Notice of Intent

Sundry ID: 2778457

Type of Action: APD Change

**Procedure Description:** OXY USA Inc. respectfully requests approval to amend the subject well(s) AAPD to update the production string cement from 13.2ppg Class H/Poz slurry to a 13.3 Class C/Poz slurry. See the attached drill plan revision summaries and lab test for reference. No surface hole changes or additional disturbance are related to this sundry.

**Laboratory Cement Test Report**  
**MIX 2023-3651 – OXY – HP479 – CHUCK SMITH MDP1 8\_17 FED COM 022H – Production – 13.3ppg**  
**Tail**  
**Service Order: 74499**

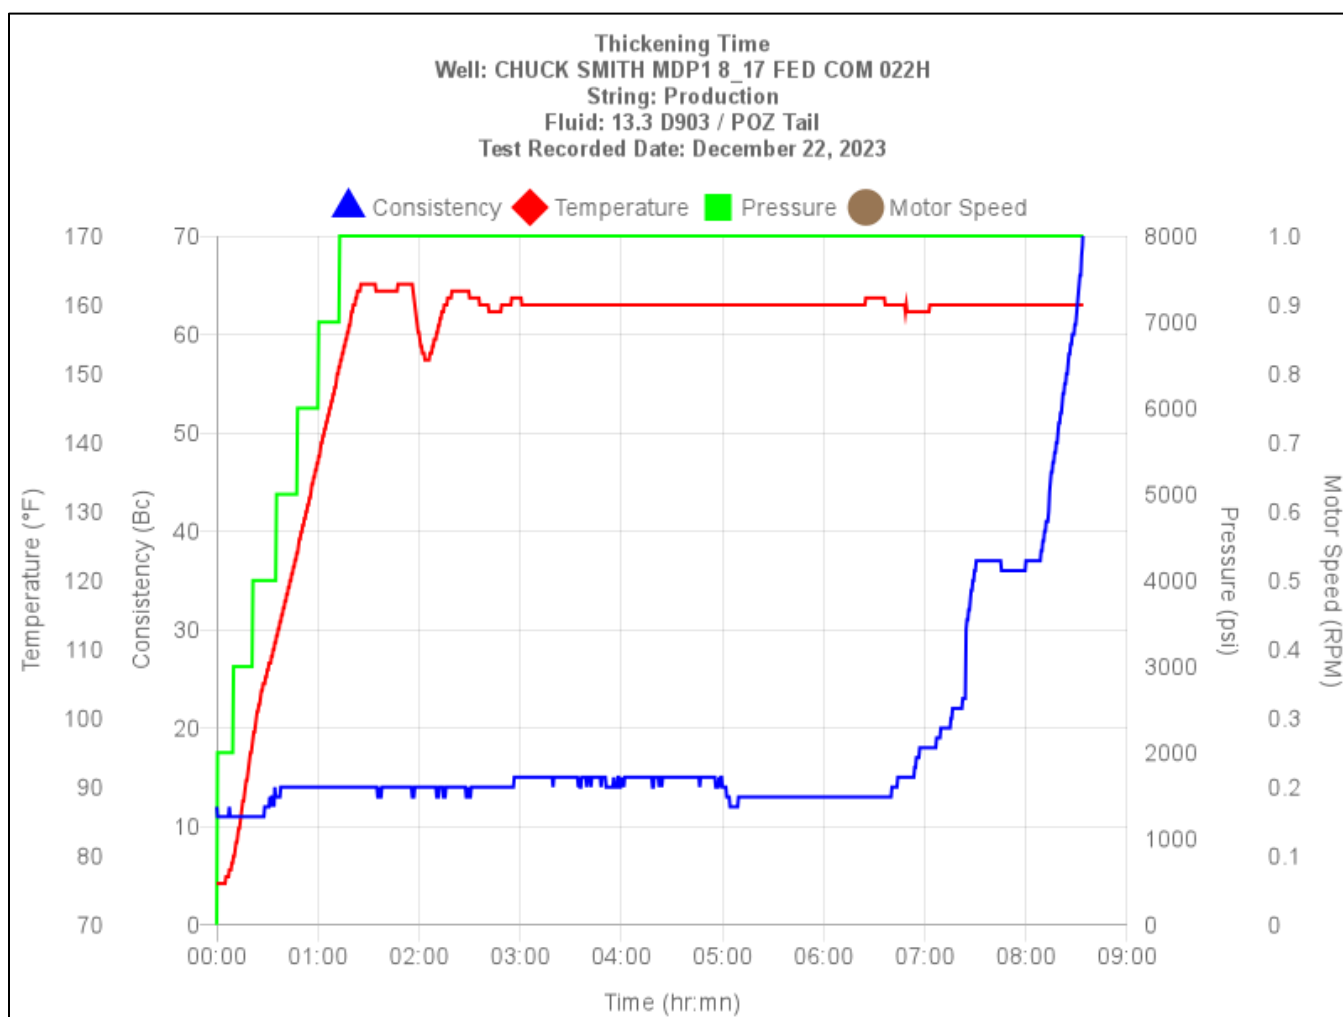
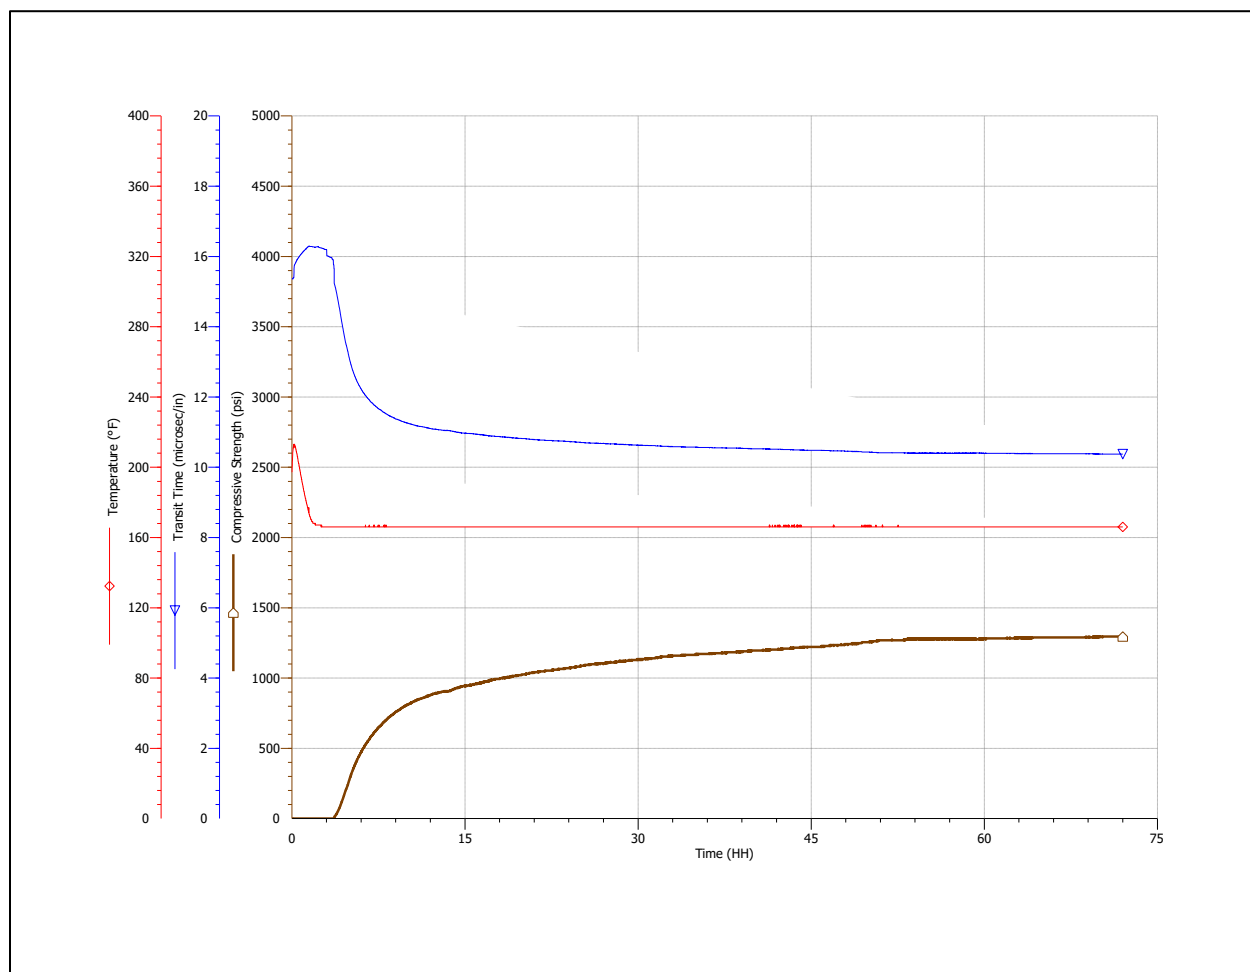
Note: When compared to the Class H / Poz system(s), the Class C / Poz slurry achieved earlier (faster) compressive strength development.

Class H / Poz: 500 psi 13:12 hr:mn

Class C / Poz: 500 psi 06:10 hr:mn

Time	Compressive Strength	Temperature
03:58 hr:mn	50 psi	160 degF
06:10 hr:mn	500 psi	160 degF
24:00 hr:mn	1069 psi	160 degF
48:00 hr:mn	1241 psi	160 degF
72:00 hr:mn	1294 psi	160 degF
Machine S/N:	640
